### AGENDA CITY PLANNING COMMISSION

City Hall - Council Chambers 6131 Taylorsville Road February 15, 2022 6:00 P.M.

Subject: ZC 21-45 (Major Change to the Basic and Detailed Development Plan in a Planned Commercial District – 5840 Old Troy Pike.

Subject: PC 22-04 Minor Change to PUD Signs for Popeyes and Dunkin Donuts – Huber Heights Commons

ADMIRAL ENGINEERING & SURVEYING INC. 14 WEST FIRST STREET DAVTON. OHIO 45402 937-223-5807 FAX 937-223-5807
SARACH, LLC 5840 OLD TROY PIKE HUBER HEIGHTS, OHIO
REVISIONS
PROJECT NUMBER 21-030 DRAWN: DWB DATE: 10-7-21 CHECKED: CSH DATE: 10-29-21
CAD FILE 21030-bose DATE 12-27-2021 SHEET NAME
SHEET No.

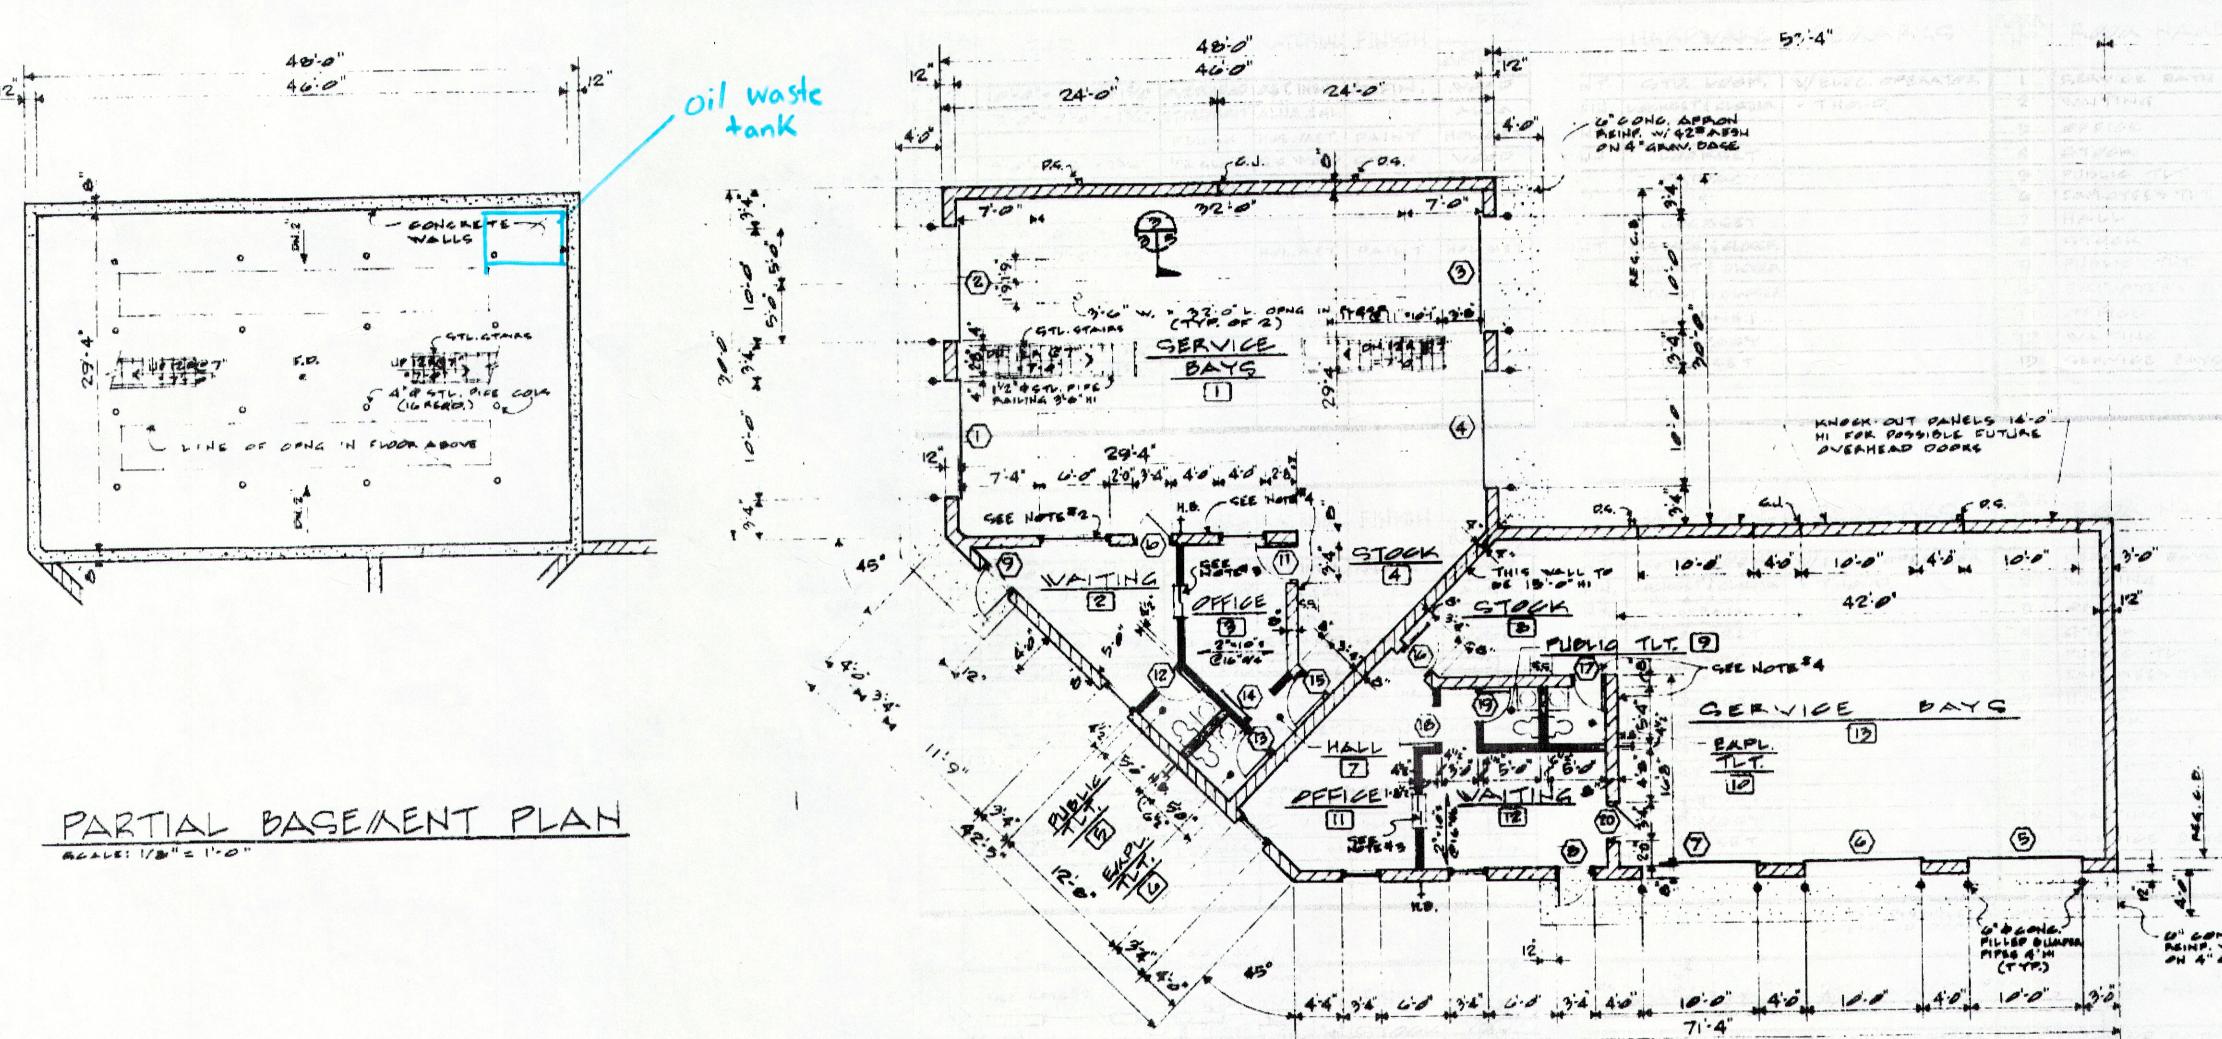
The revised plan includes a 42" hedge, 60-feet long, between the display area and the property line. While this does help buffer the display area from the adjoining property, the proposed plan reduces the existing required yard buffer from 15-feet (required in the PC District) to approximately 7-feet.

Both the original and revised plan locate the vehicle display area 25-feet from the rightof-way. While this meets the zoning standards for a parking area, the proposed plan shows three tightly packed display rows. This will have a greater visual impact along Old Troy Pike than a traditional parking area with one row of parked vehicles, separated by a 20-foot drive aisle. Additionally, parking areas of this size would be required to have interior parking landscaping to break up the mass of the vehicles and reduce storm water runoff. There are little to no recently developed uses within the vicinity that have such concentrated vehicular display or parking areas.

The proposed site plan brings the site out of conformance with the yard standards set in 1176.03(b)(1), described above.

If the Planning Commission deems the vehicle display area as a parking area, the site plan is not in conformance with the parking requirements found in Chapter 1185.

# LAYOUT PLAN

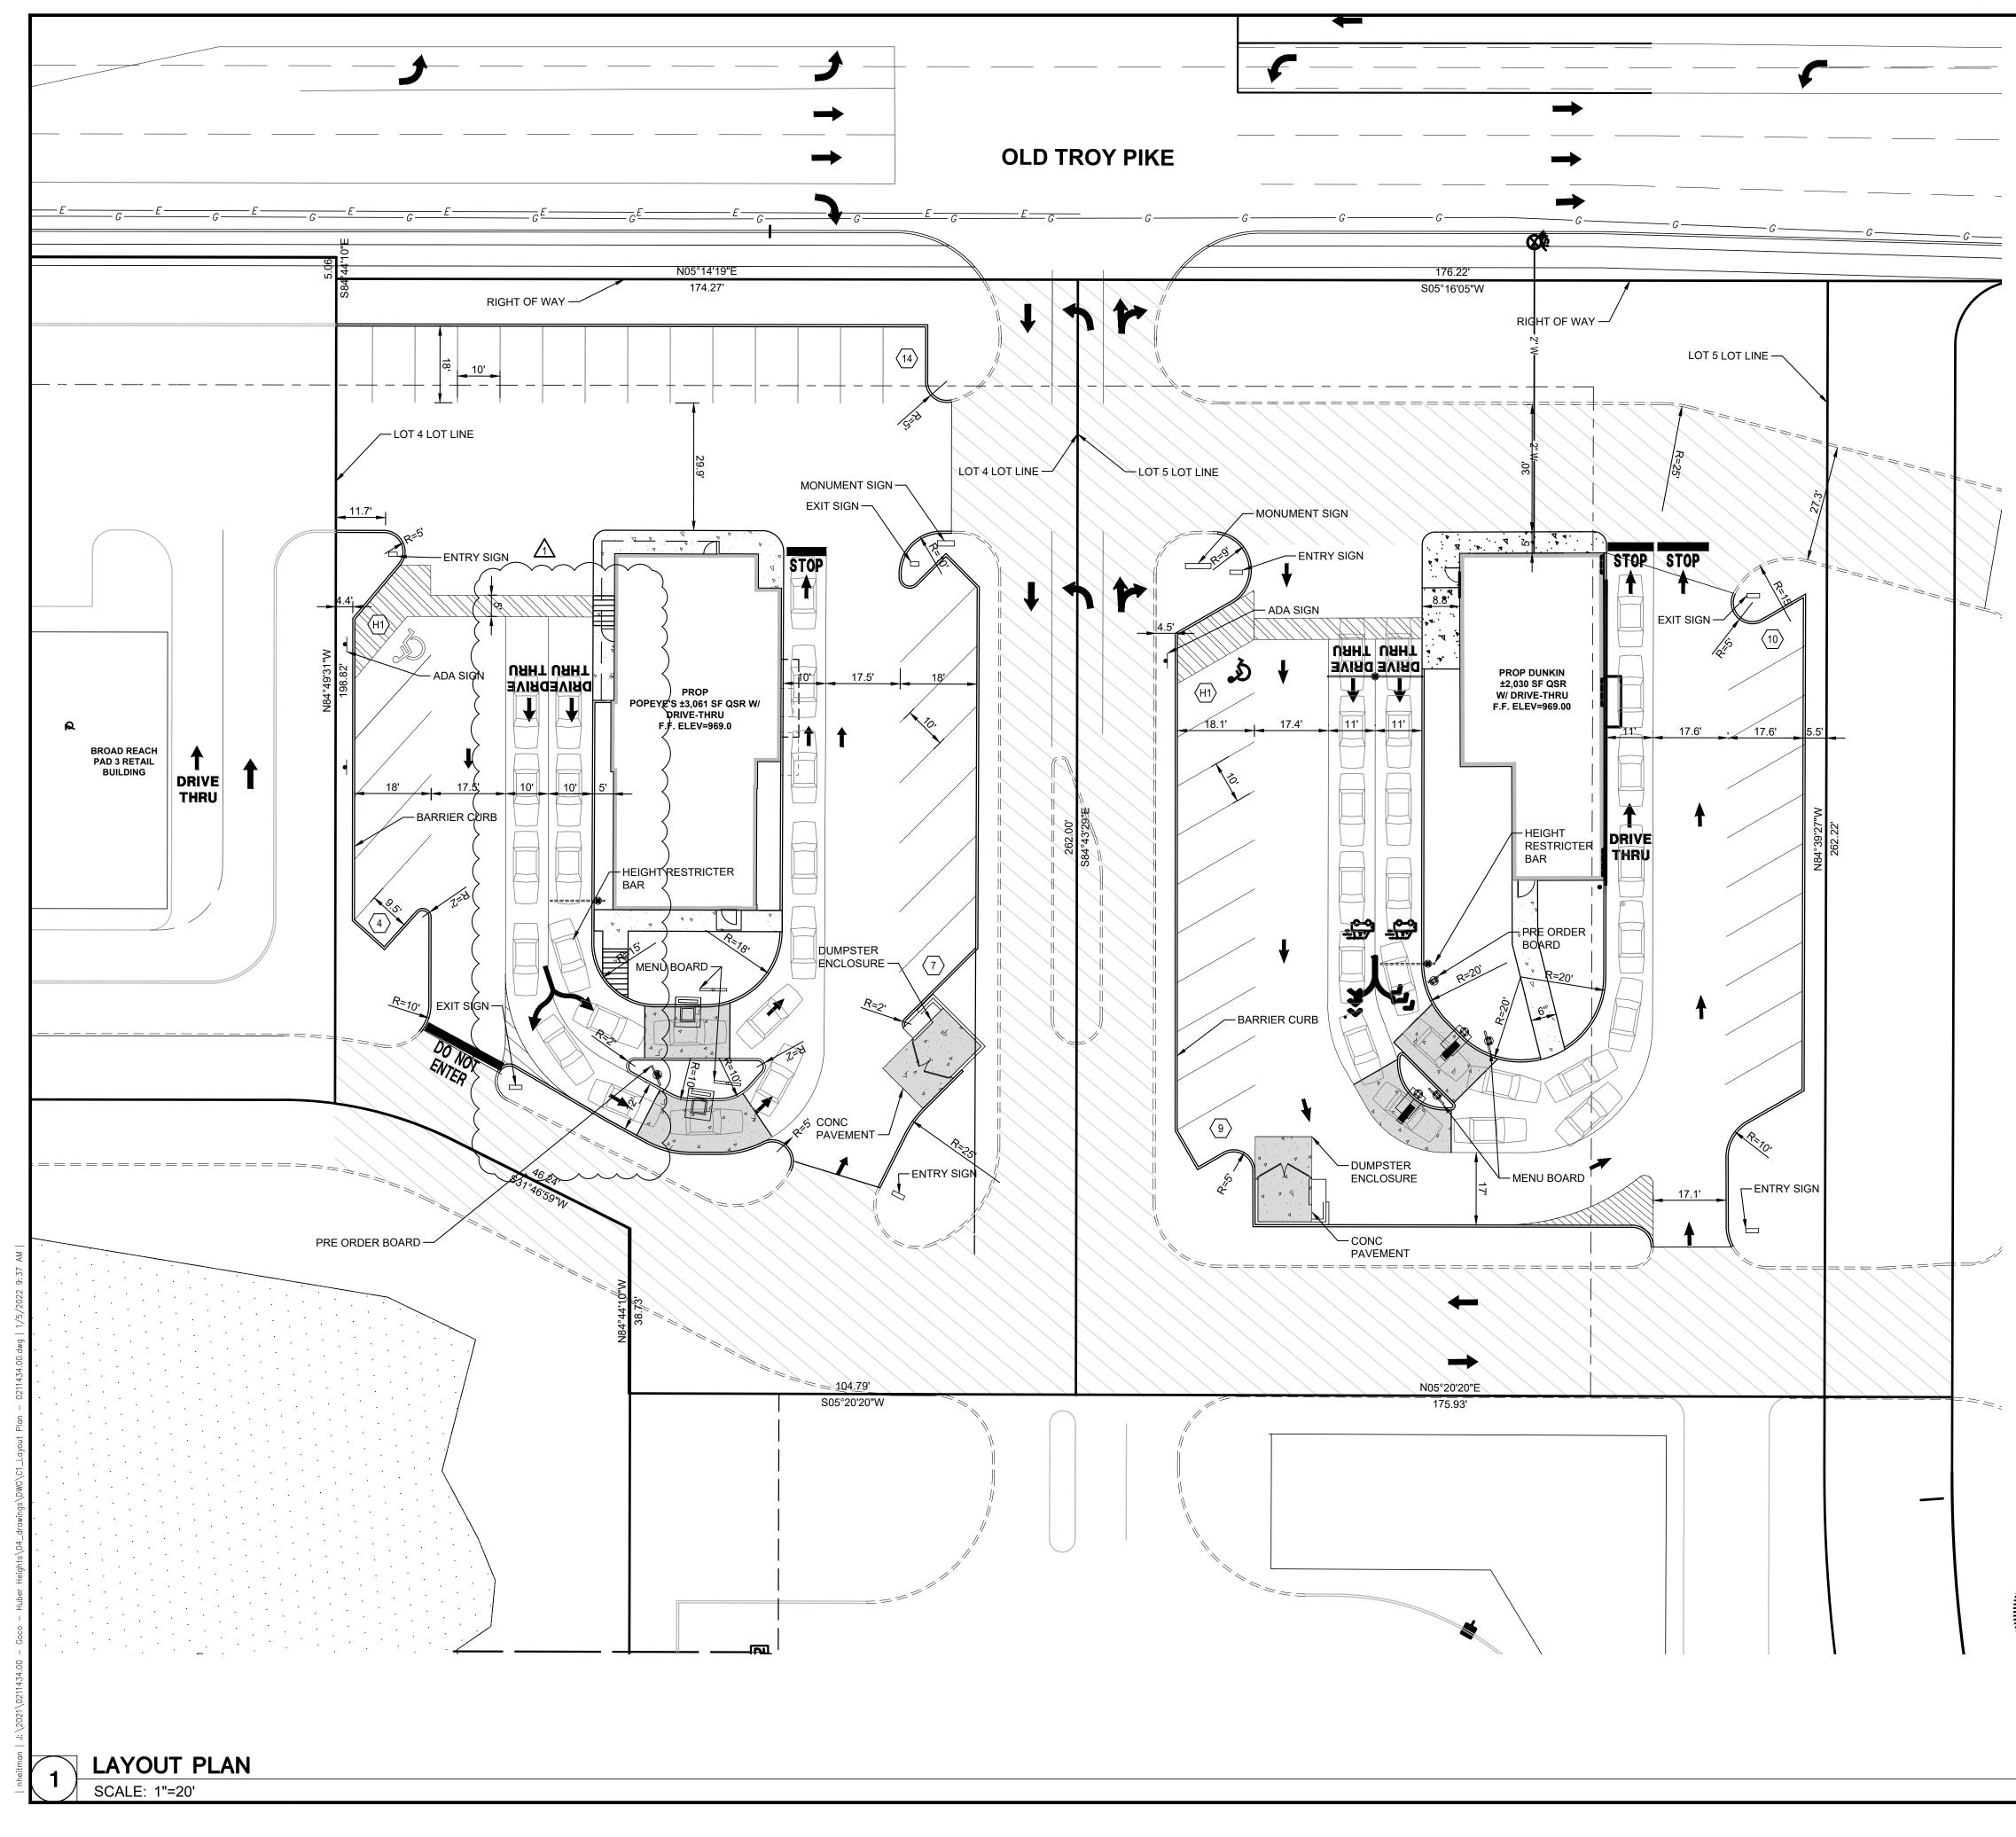
The site plan indicates one internally illuminated monument ground sign facing Old Troy Pike, set back nearly 70 feet from the property line. The sign sits on a brick base and the total height is 6-feet, including the base. The sign size is just under 27 square feet. This complies with the sign regulations in chapter 1189.

The site plan also indicates three directional signs. The details of the directional signs for Dunkin Donuts were not submitted. The sign code limits to the sign face to 2 square feet per side, and maximum height of 3-feet.

The site plan indicates one digital pre-order board and two digital menu boards in the drive-thru lanes, each with 100% electronic changeable copy. Each menu board is a total of 6'-10" high, including a 2-foot metal pedestal. The menu display itself is 5-feet wide and 4'-7" tall (approximately 22.9 square feet). The zoning code is silent on menu boards, but historically staff has approved them as ground signs, noted they are menu boards and not counted them against the one ground sign limit per site. While slightly taller than the maximum ground sign height, the increased height puts the menu board at a better viewing angle for drive-thru customers. While the zoning code limits changeable copy to only 50% of the sign area, staff recommends approval of 100% electronic changeable copy because this enables the total sign area to be smaller.
